Correspondence Between Staff and Applicant

RE: 14-ZN-2018  
South Scottsdale Mixed-Use  
J2859 (Key Code)

Project: South Scottsdale Mixed-Use  
1000 N Scottsdale Road  
Scottsdale, Arizona 85287

REVISIONS	
Phase:	DR
Drawn By:	AF/OM
Reviewed By:	DH
SDI Project No:	3819
Date:	10/07/2019
Sheet:	DR1-1 SITE PLAN

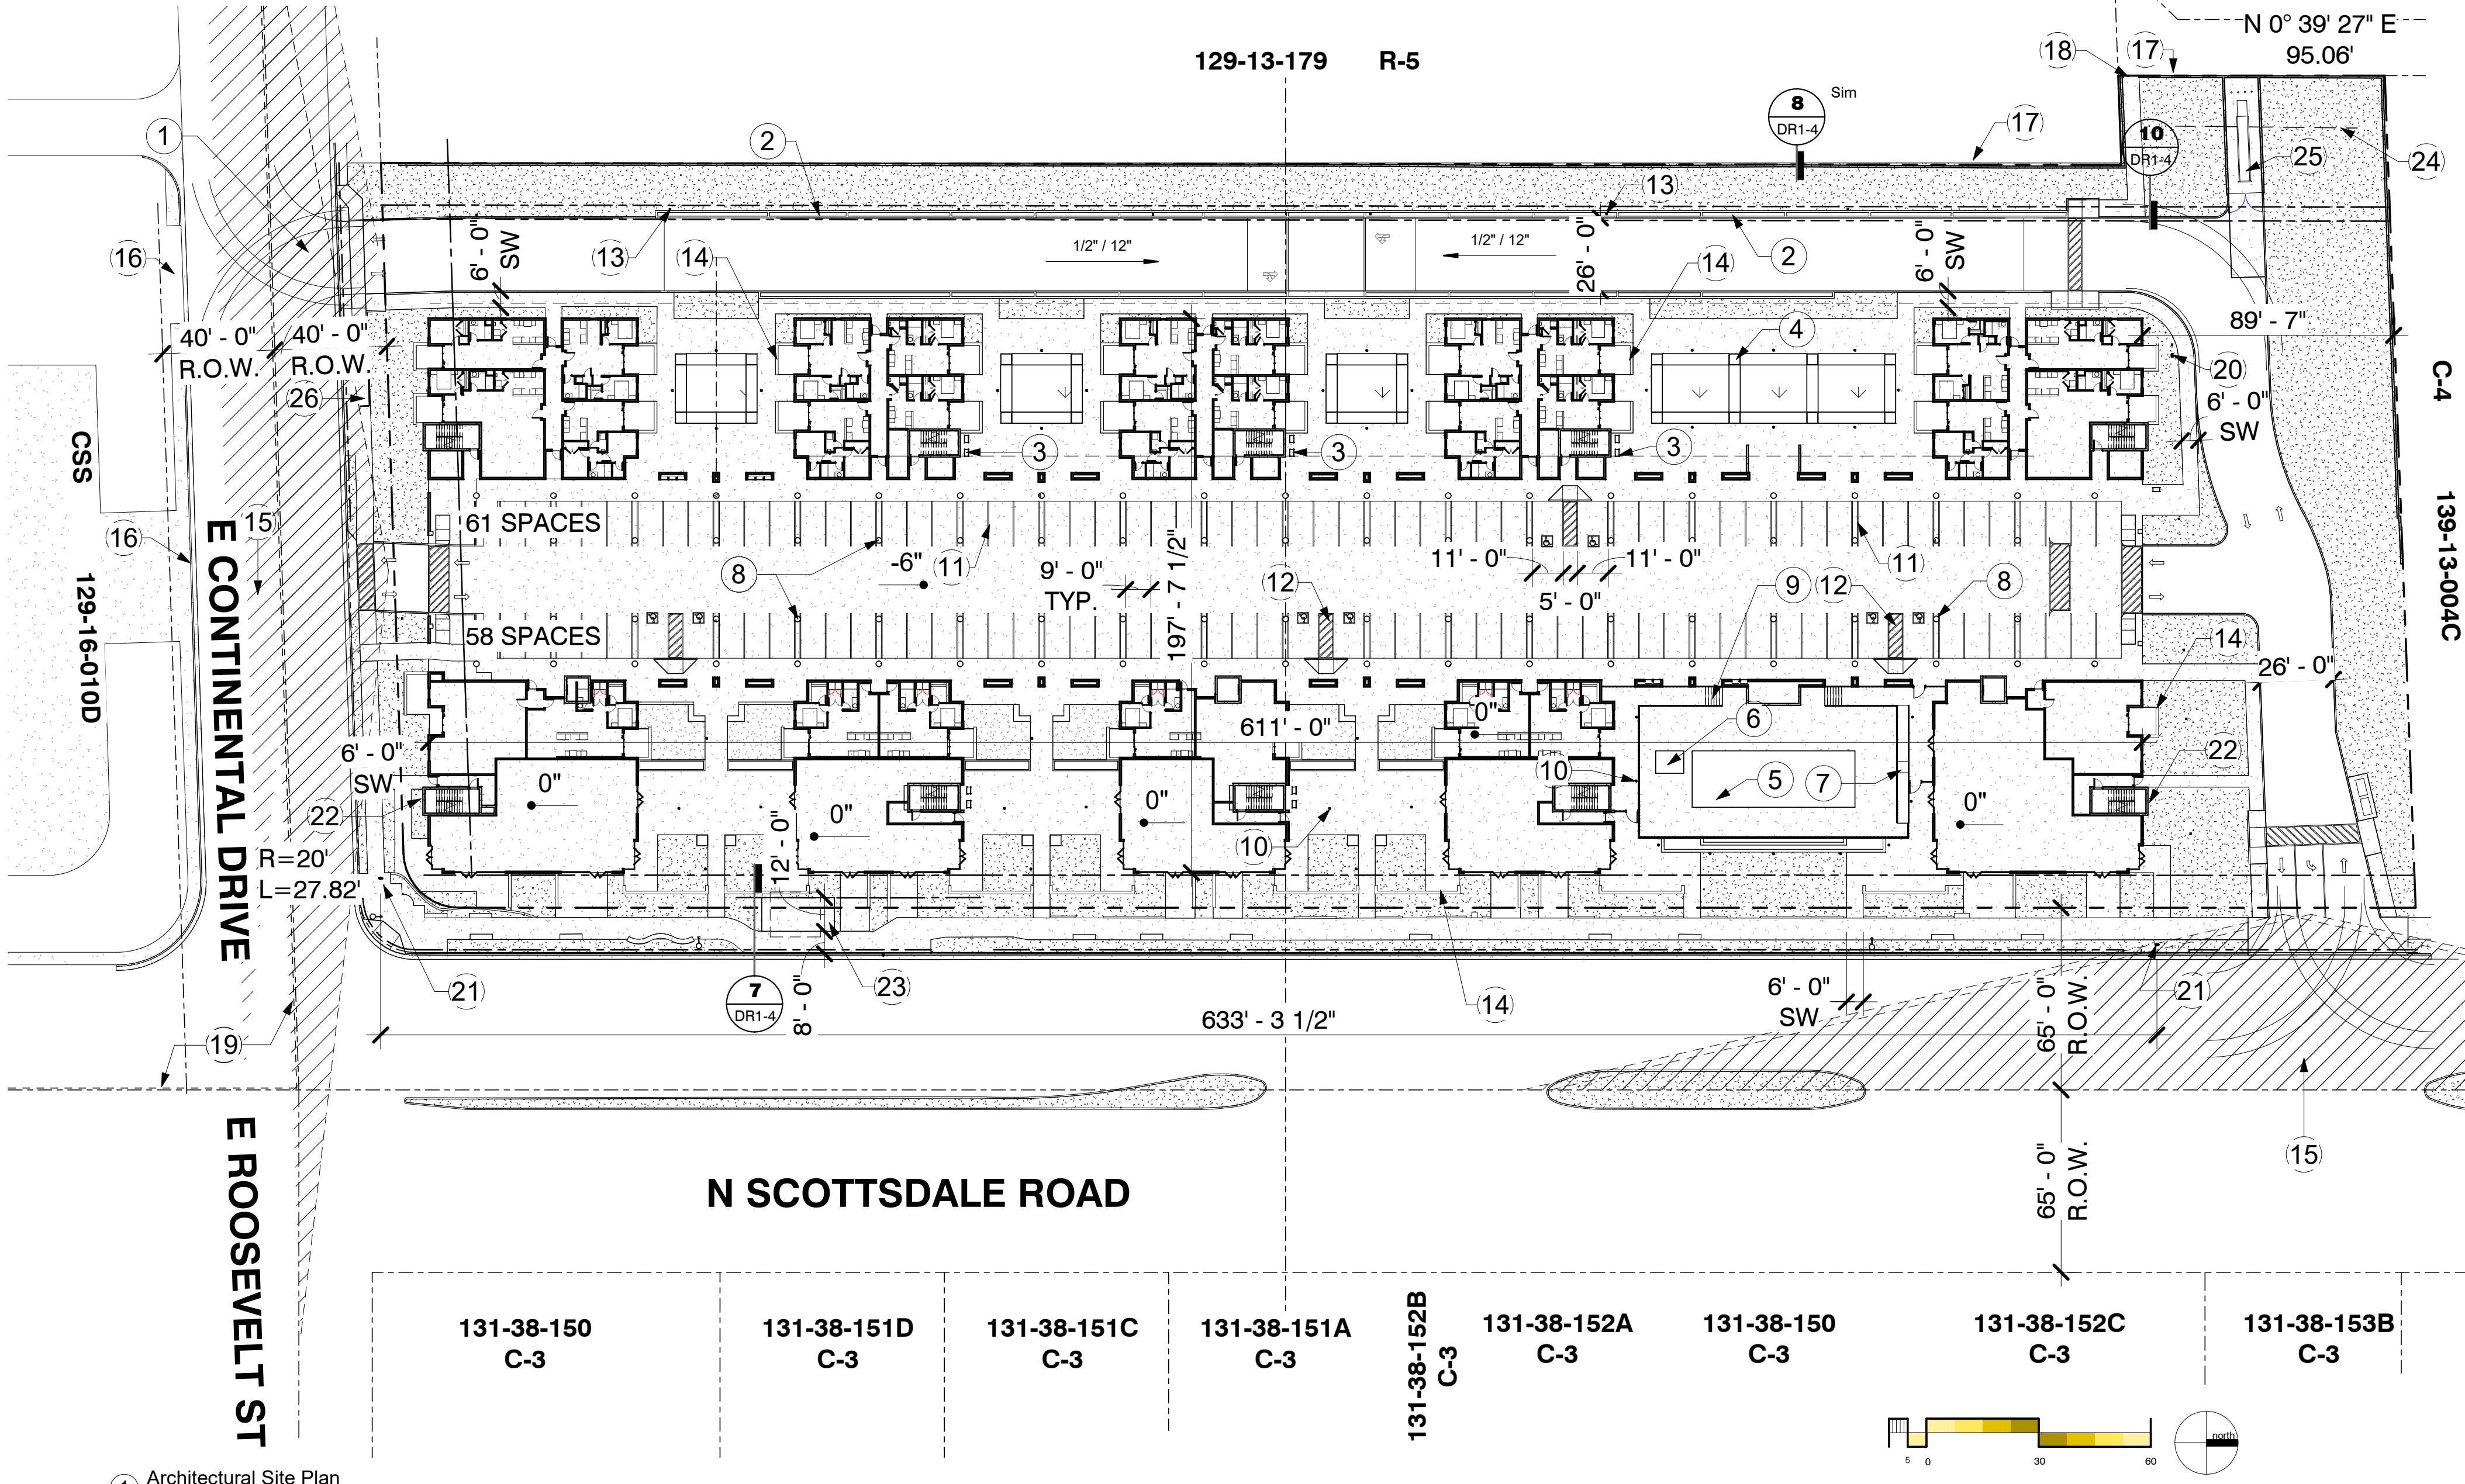
1. Please revise the applicable plans to indicate a minimum 6-foot side sidewalk, detached from the street curb, along the entire Continental Drive frontage. Refer to Section 5-3.110 and 5-8.300 of the DSPM.

2. Please revise the applicable plans to indicate required sight distance easements at all proposed driveways. Refer to Section 5-3.123, Figure 5-3.25 of the DSPM.

4. Any proposed soil nailing for the parking garage is required to follow Section 1-3.600 of the DSPM. Please add note to site plan accordingly to acknowledge this requirement.
5. Please revise the site plan to illustrate and call out the jurisdictional boundary. **City of Tempe approval is required for site access onto Continental Drive and must be received prior to the Planning Commission hearing.** Consent can be in the form of a letter or email from the appropriate staff.

1. Please revise the applicable plans to indicate a minimum 6-foot side sidewalk, detached from the street curb, along the entire Continental Drive frontage. Refer to Section 5-3.110 and 5-8.300 of the DSPM.

2. Please revise the applicable plans to indicate required sight distance easements at all proposed driveways. Refer to section 5-3.123, Figure 5-3.25 of the DSPM.

4. Any proposed soil nailing for the parking garage is required to follow Section 1-3.600 of the DSPM. Please add note to site plan accordingly to acknowledge this requirement.

5. Please revise the site plan to illustrate and call out the jurisdictional boundary. City of Tempe approval is required for site access onto Continental Drive and must be received prior to the Planning Commission hearing. Consent can be in the form of a letter or email from the appropriate staff.

**Response: Sidewalk has been modified to be detached from street curb as much as possible. Only small portion where existing bus stop and shelter remain is still attached to curb for pedestrian connection. Sidewalk has been made 6 foot wide along entire frontage.**

**Response: Site distance easements have been added and/or updated at all proposed driveways.**

**Response: Noted for future items and note has been added to Architectural site plan.**

**Response: Noted. Appropriate consent is in process and will be sent as soon as we have it.**

\*ANY PROPOSED SOIL NAILING FOR THE PARKING GARAGE IS REQUIRED TO FOLLOW SECTION 1-3.600 OF THE SCOTTSDALE DESIGN STANDARDS & POLICIES MANUAL

PRELIMINARY WATER  
& SEWER PLAN

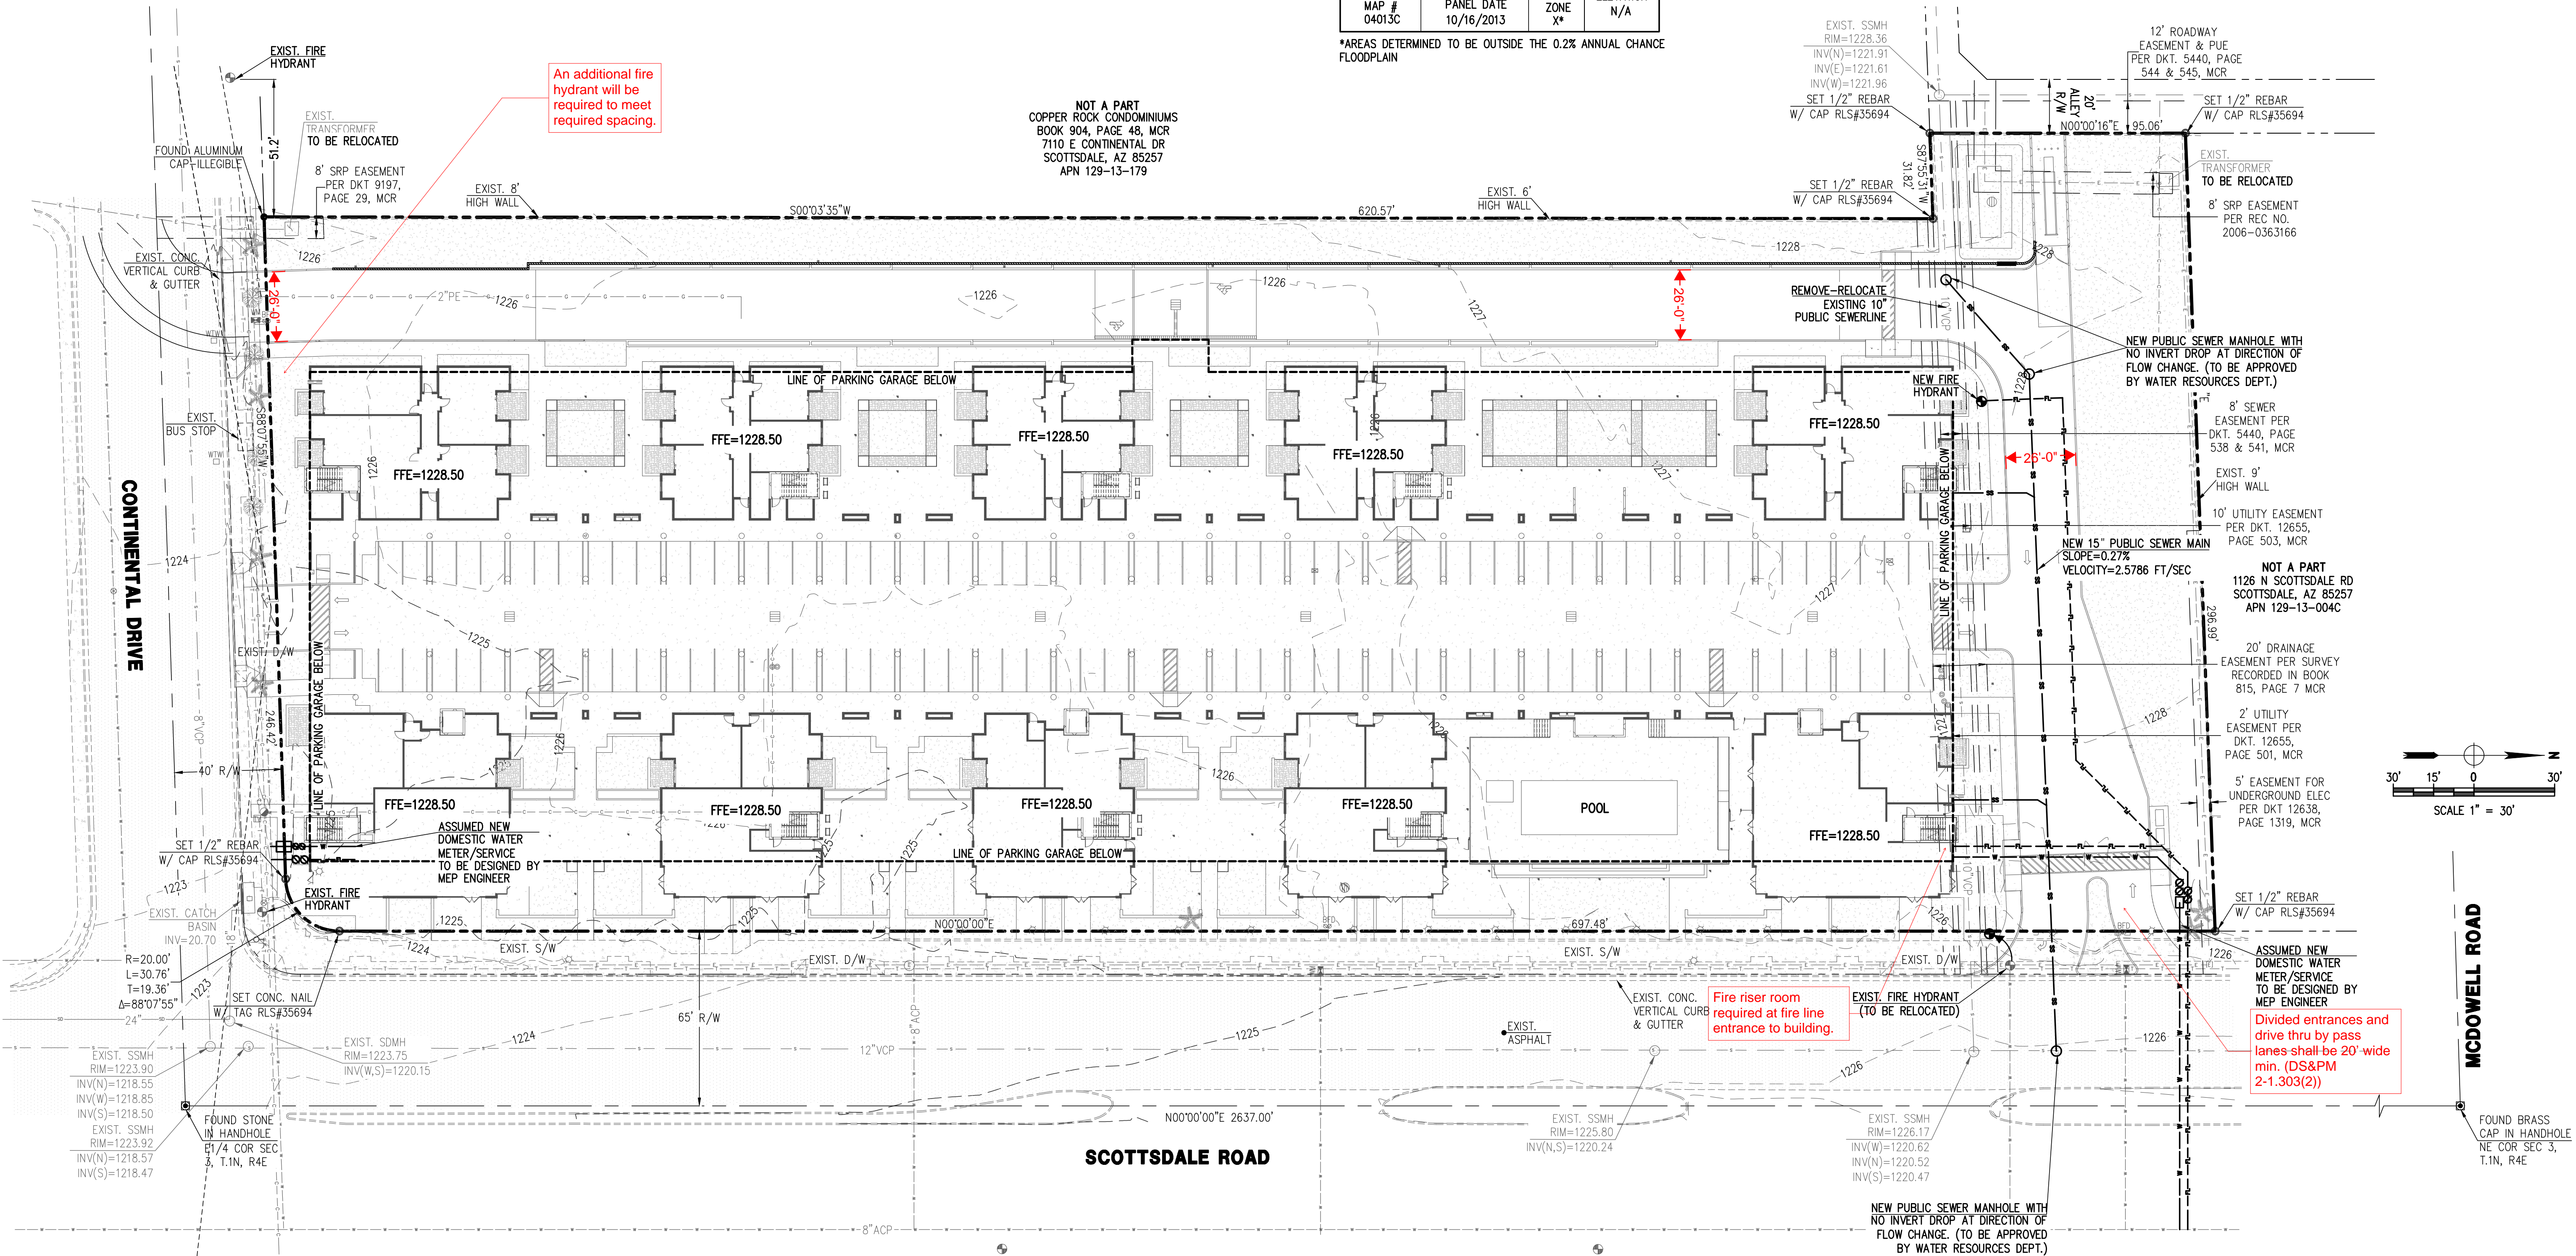
14. The proposed compactor will require a grease, oil and sand separator. This was not noted on the utility plan. Please revise utility plan accordingly.

**Response: Note has been added.**
